**PEA RIDGE PUBLIC SERVICE DISTRICT
CABELL COUNTY, WEST VIRGINIA**

CONTRACT #4 – ROUTE 2 SOUTH SANITARY SEWER EXTENSION

ADDENDUM #2

JULY 24, 2023

SHEET No.
11

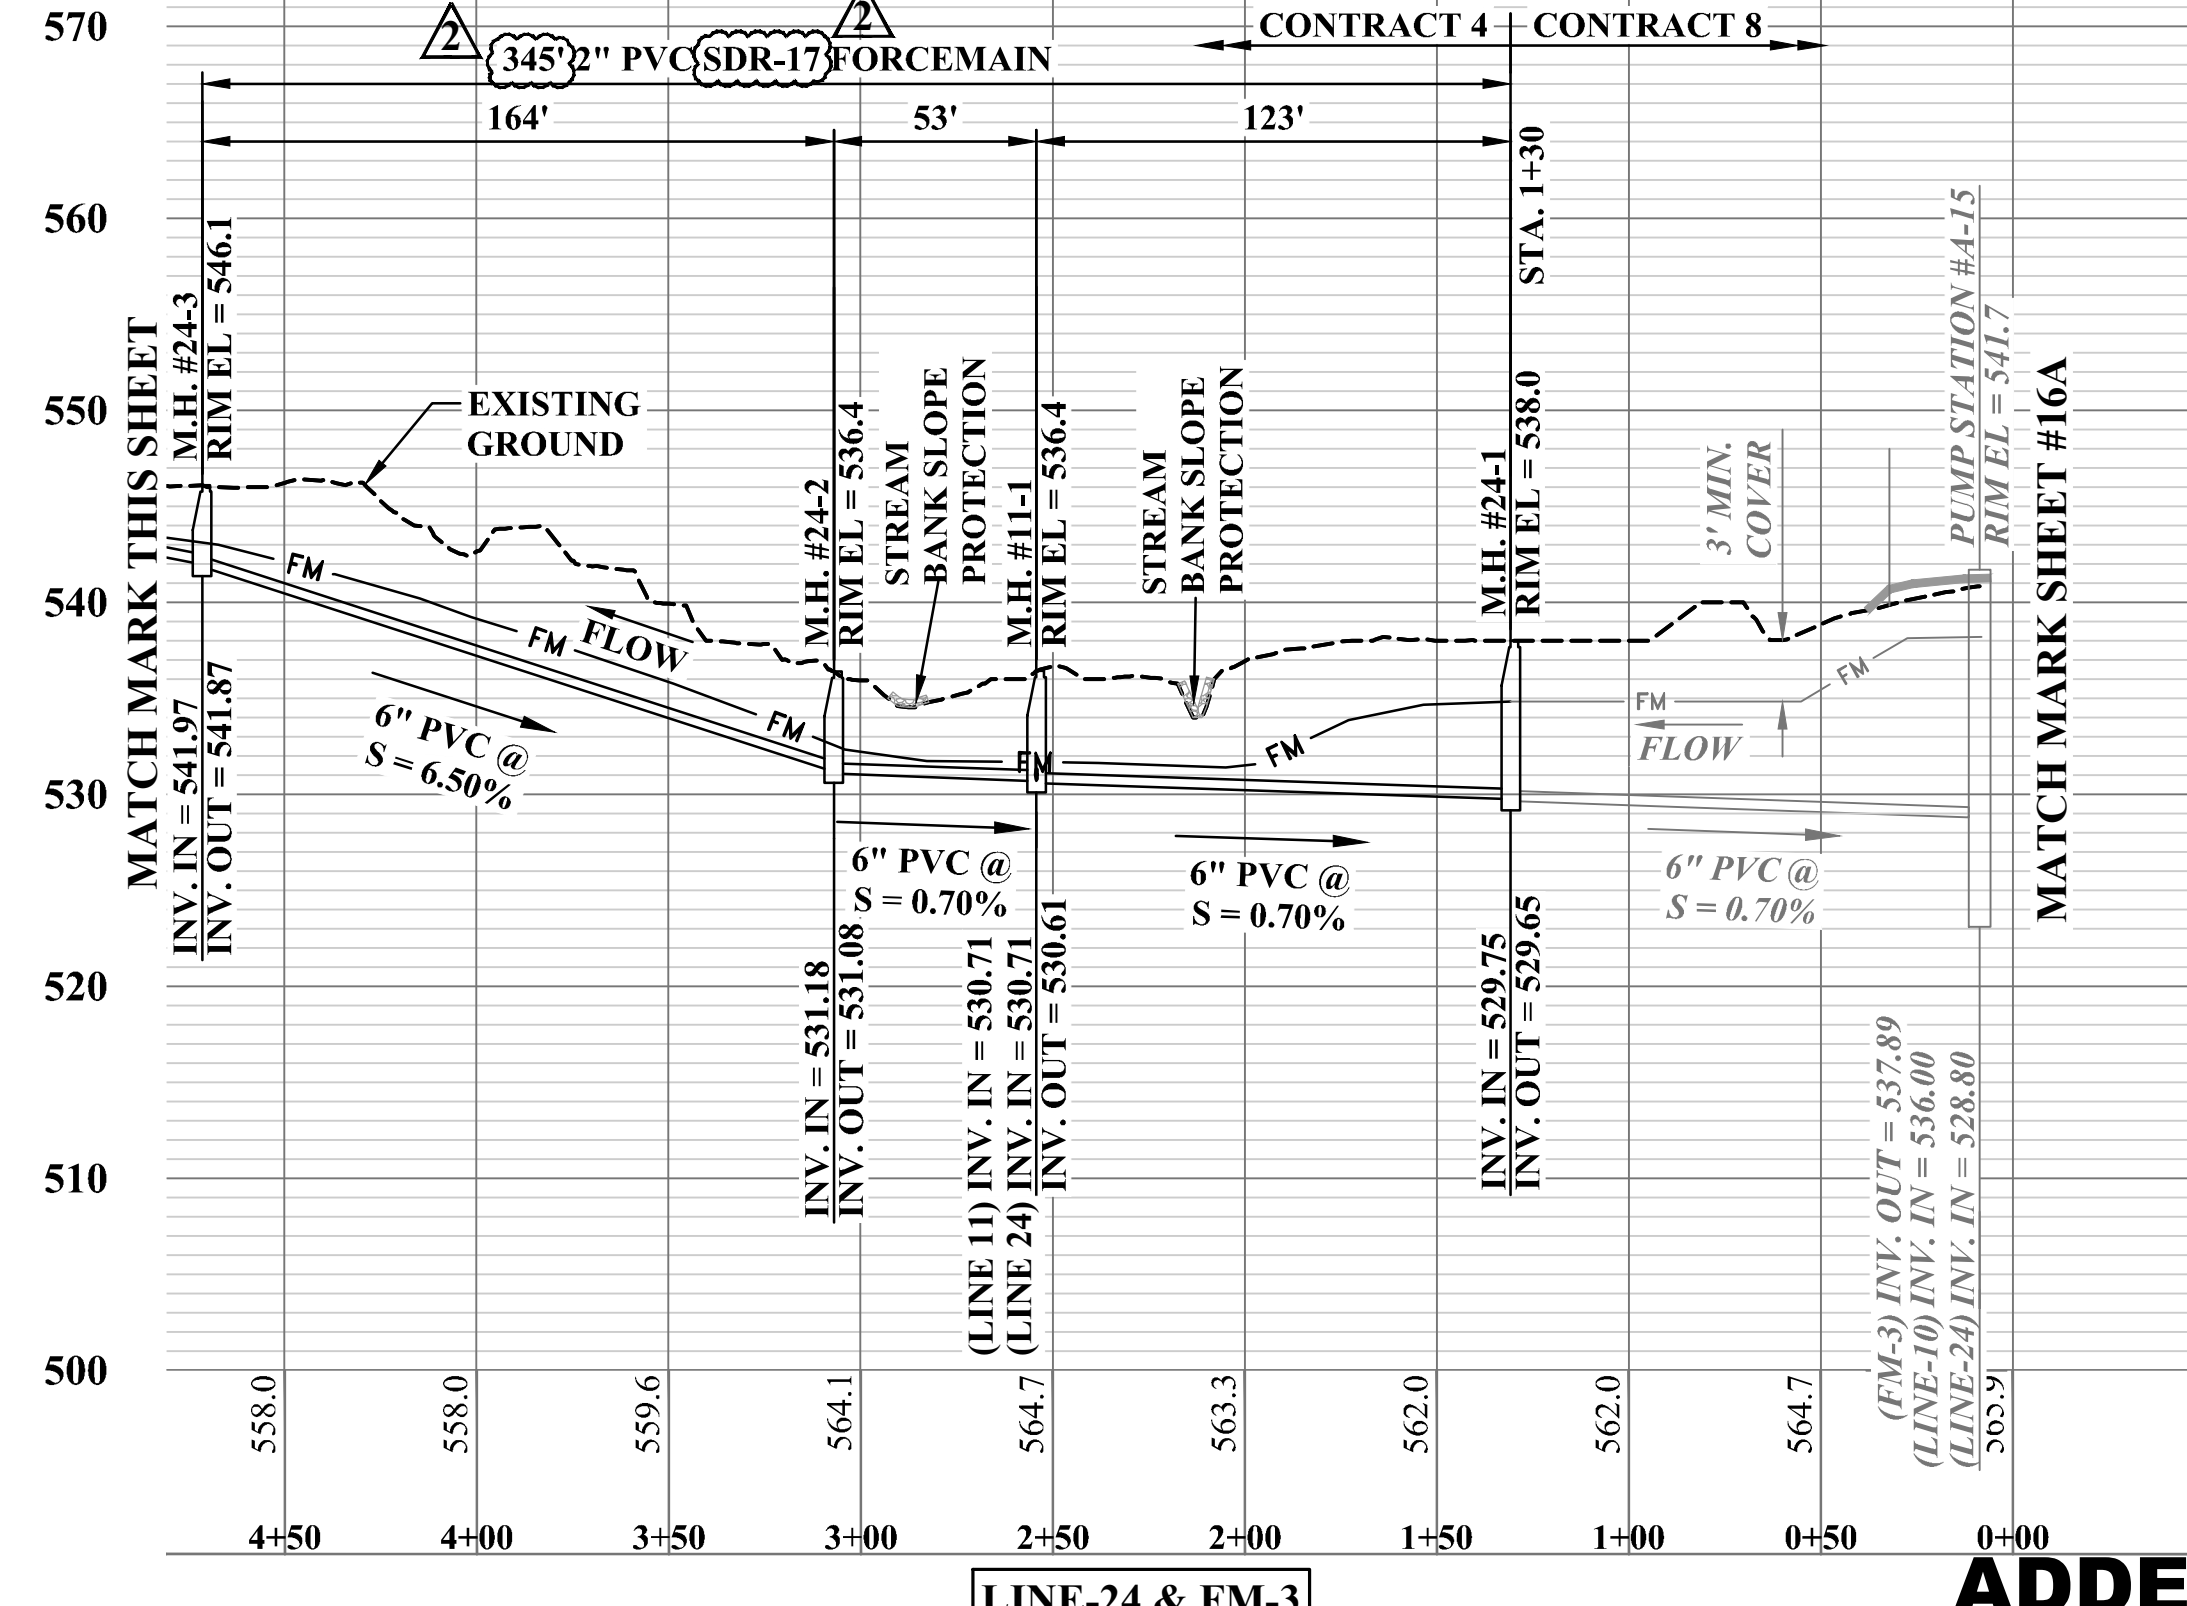
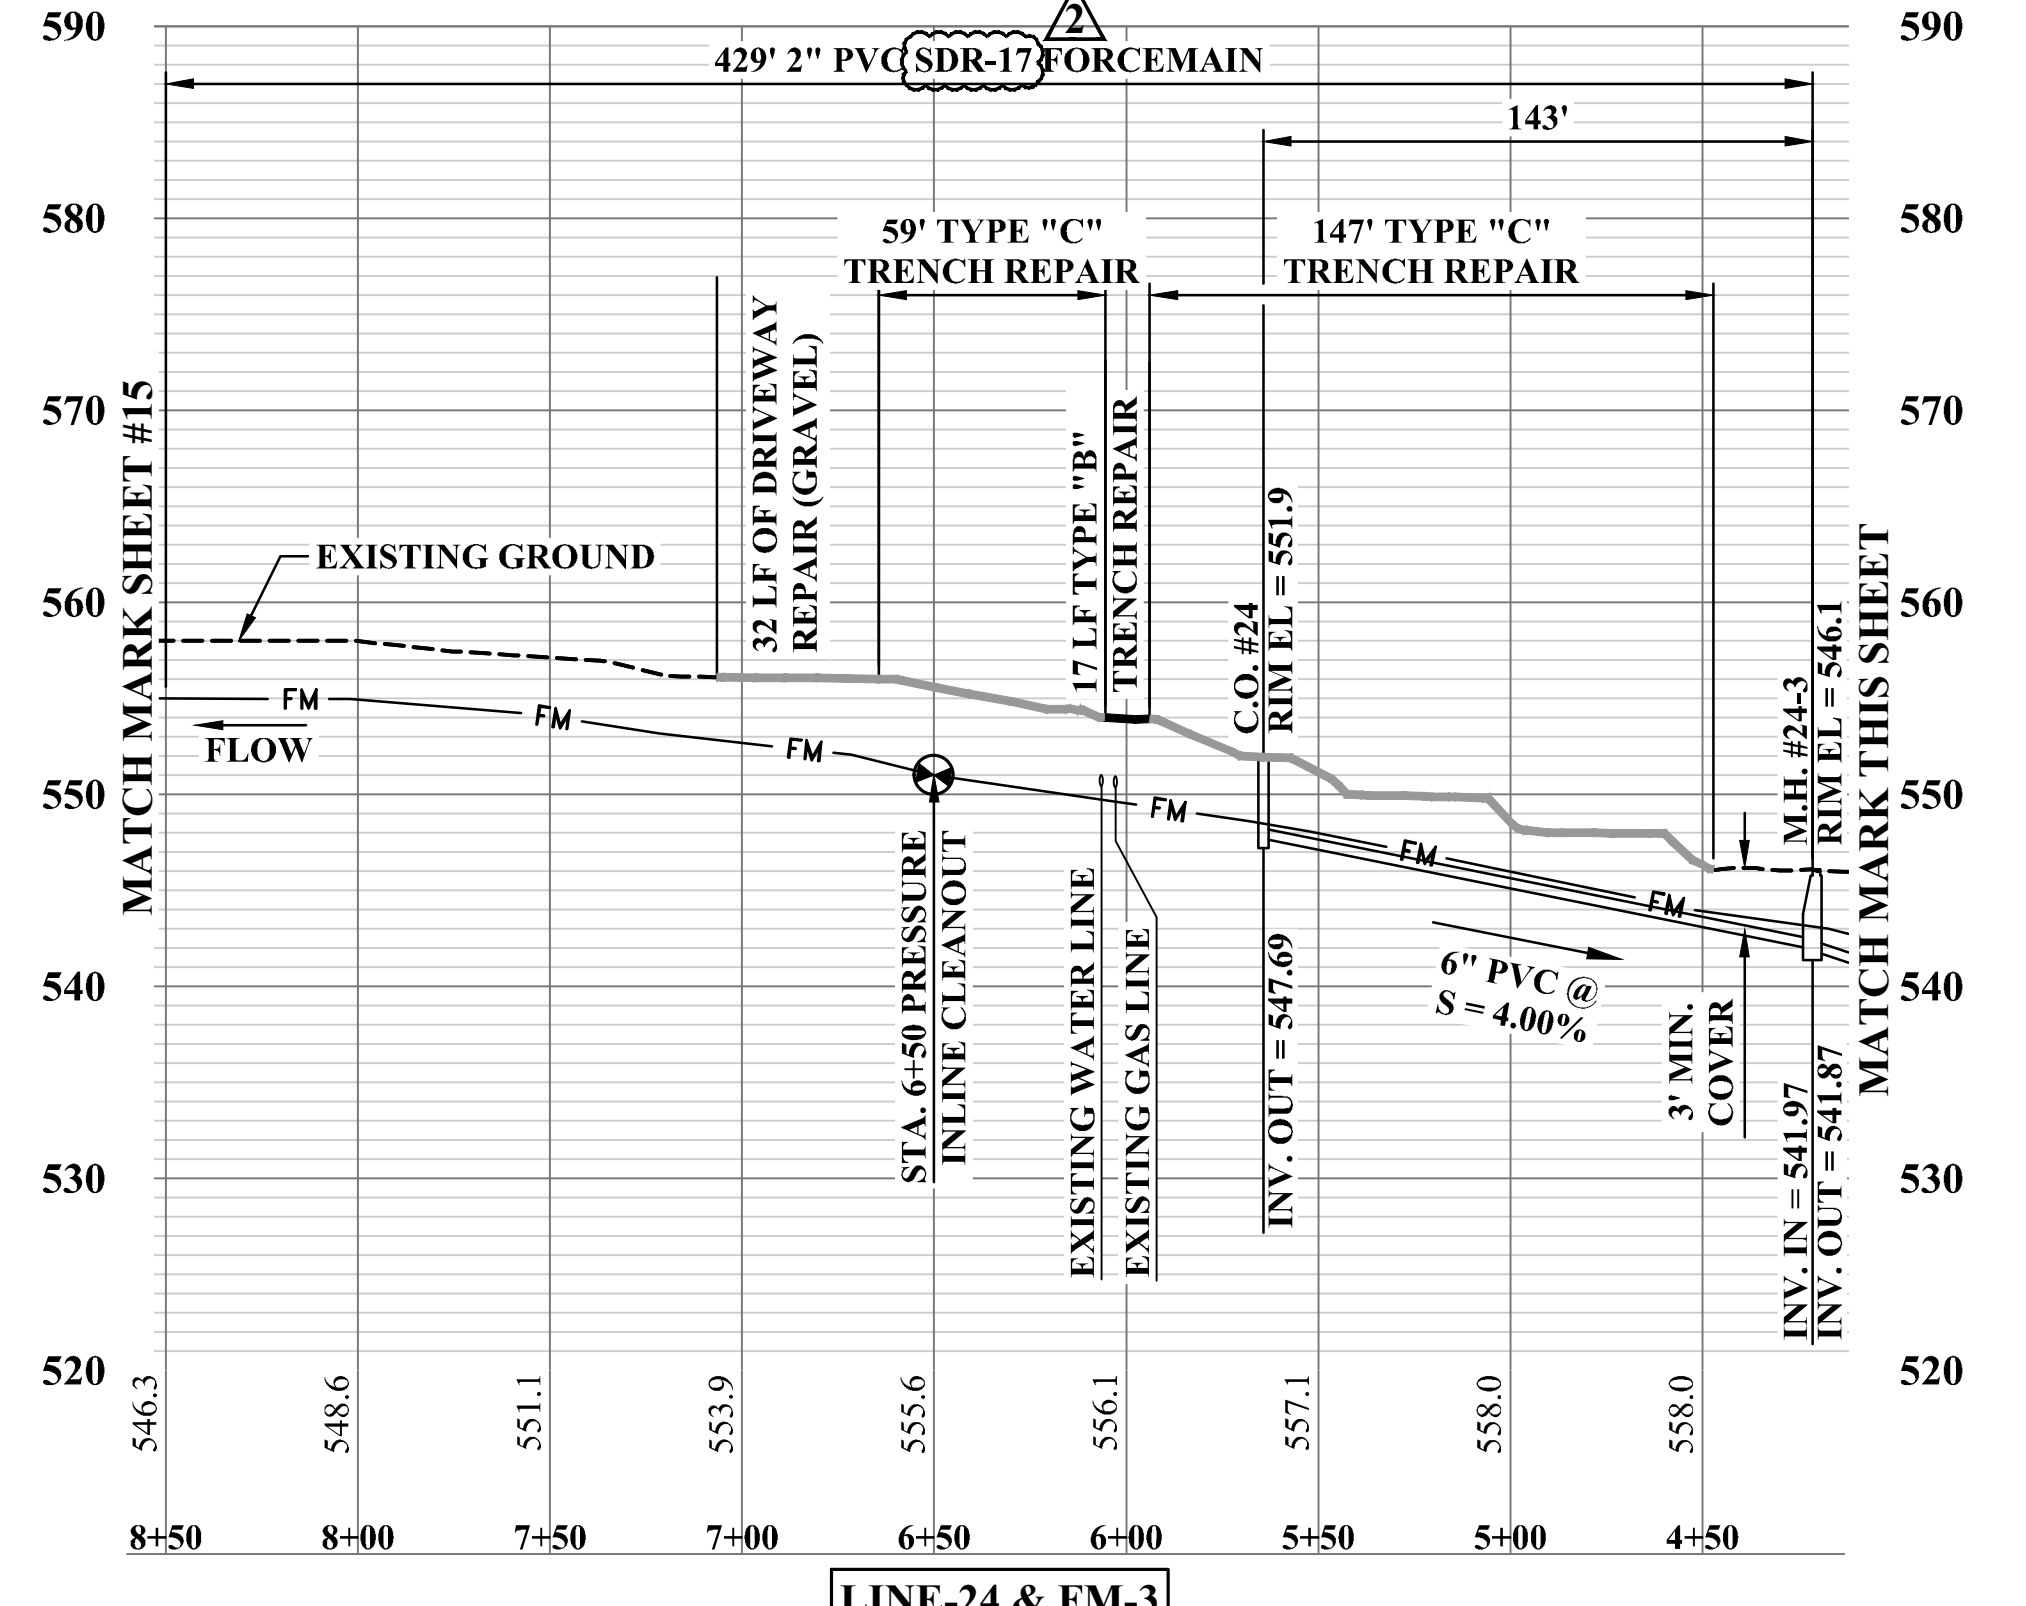
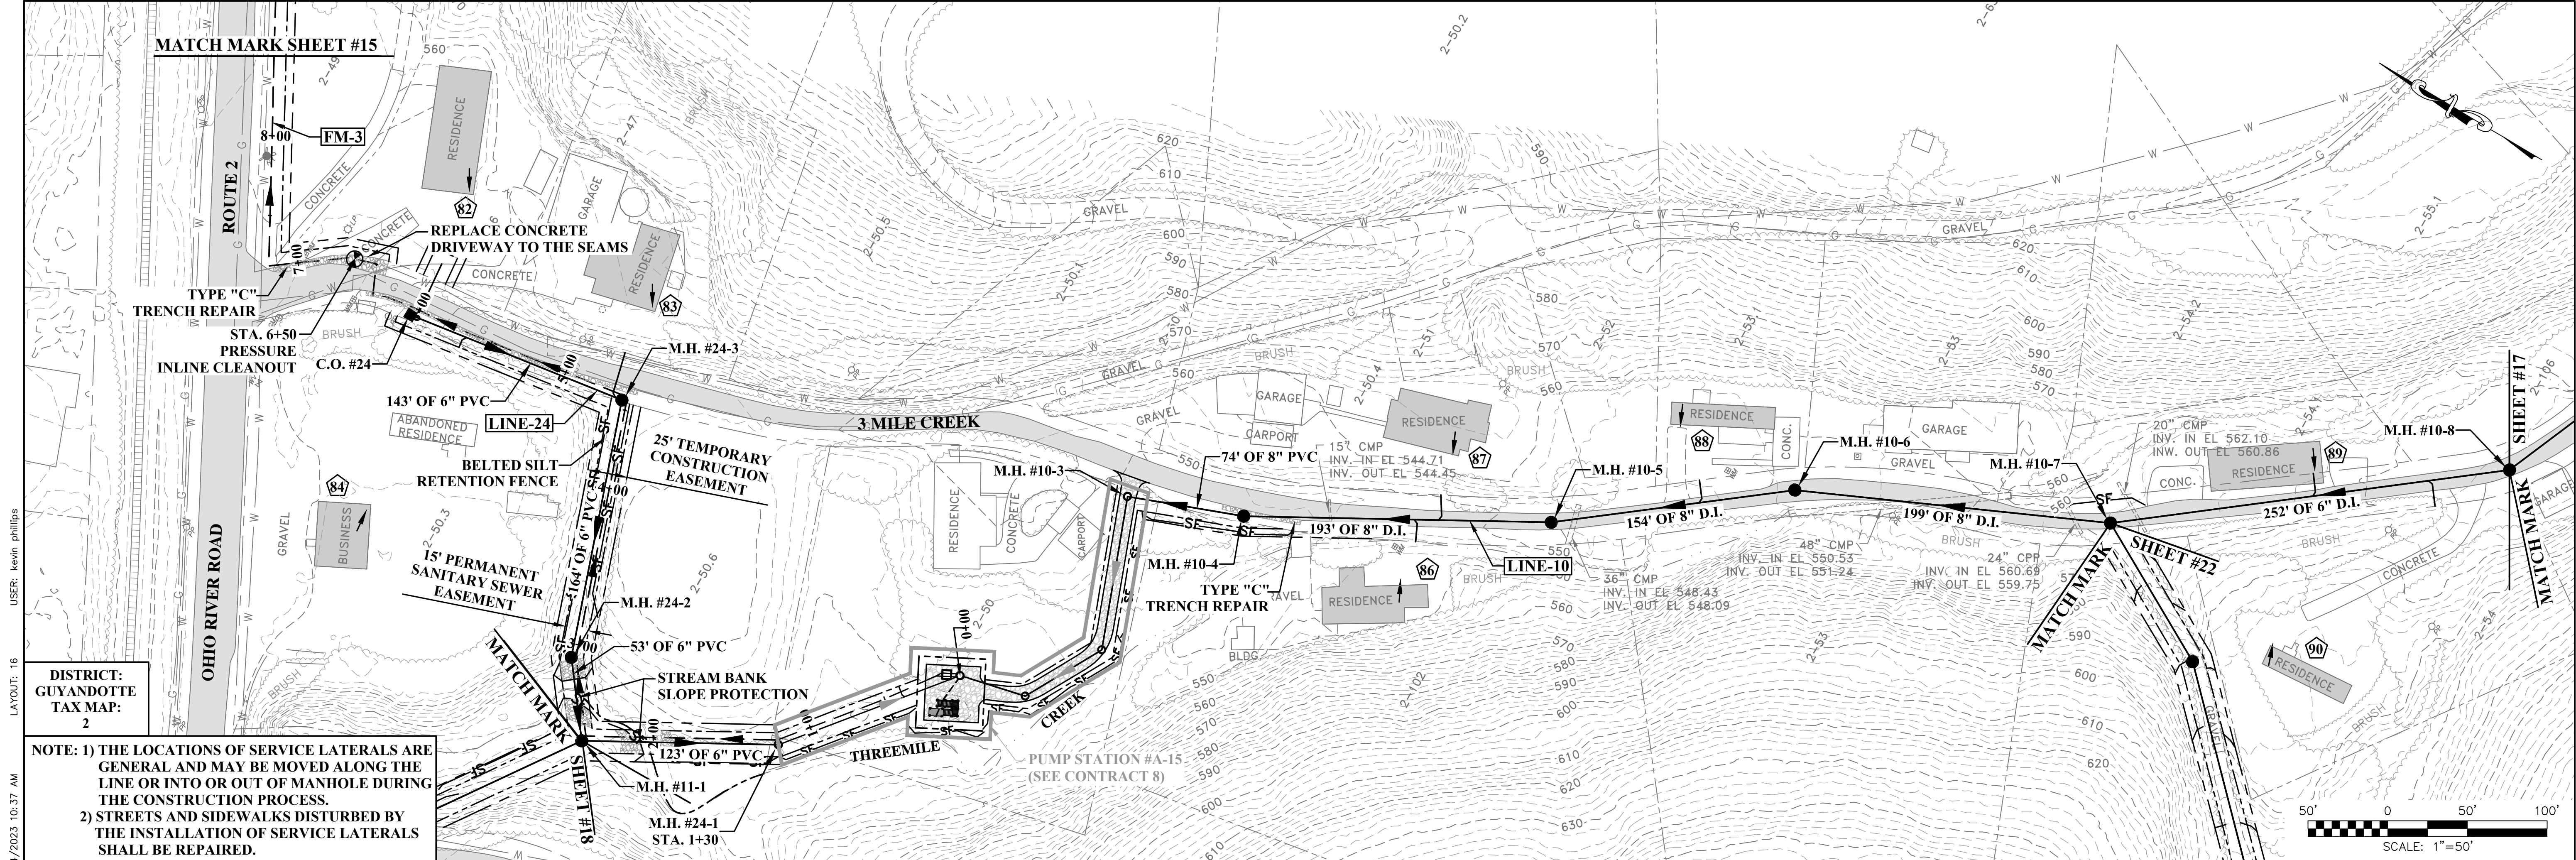
Will you add a bid item and detail for the 2.5" inline cleanout found on pages 8, 10, and 11 of the contract drawings?

The line size has been revised. A 2.5" to 3" cleanout is not needed.
